## PLANNING COMMISSION REGULAR MEETING

2. **Preliminary Site Plan Review (PPAM24-001):** The Crossing at Lakelands Trail
3. Elderly Cottage Housing Opportunity(ECHO) Discussion. Consider changes to the ECHO zoning ordinance amendment.

**Project Number:** Preliminary Site Plan Application for General Planned Unit Development (PCPUD24-0001)

# PRELIMINARY SITE PLANS FOR: **THE CROSSING AT LAKELANDS TRAIL**

L-2

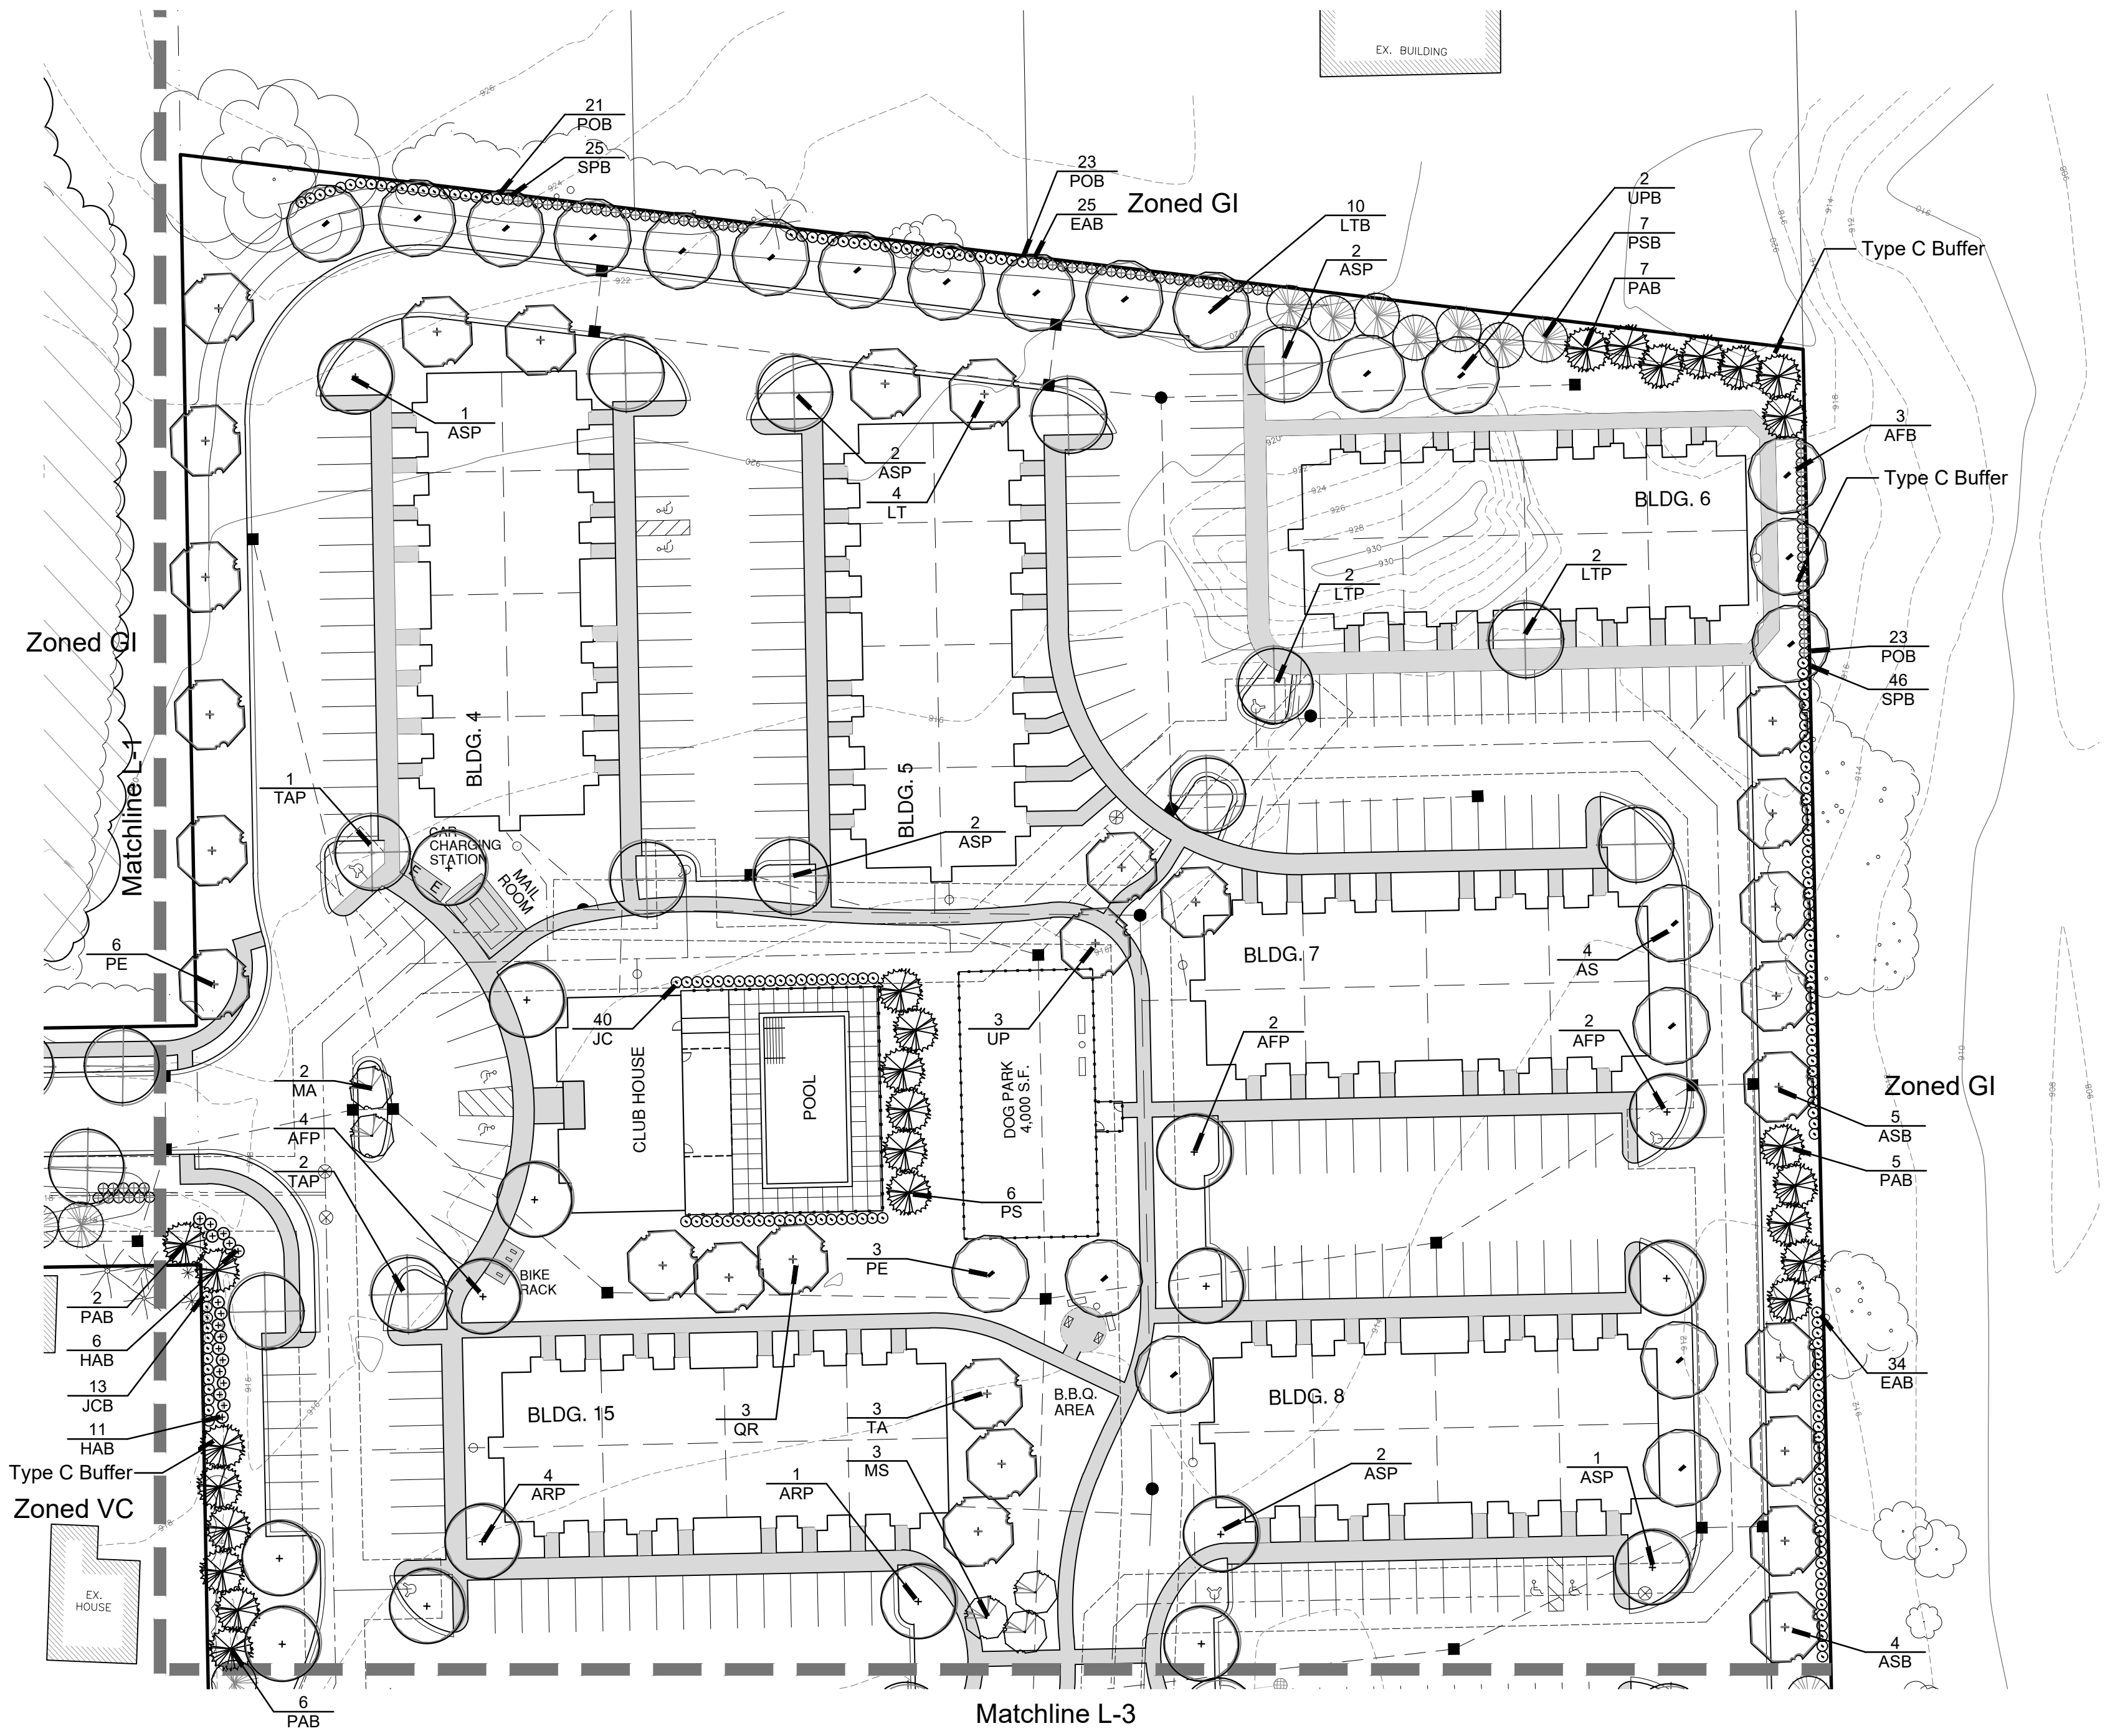
The land scaping plan does not note a 20foot buffer and proposes a six-foot vinyl fence on the southern parcel line (L-3).

Because this project is a General Planned Unit Development the landscape requirements can be set by the Development Agreement as part of the Planned Unit Development process and the Planning Commission does not need to officially waive the landscaping requirements.
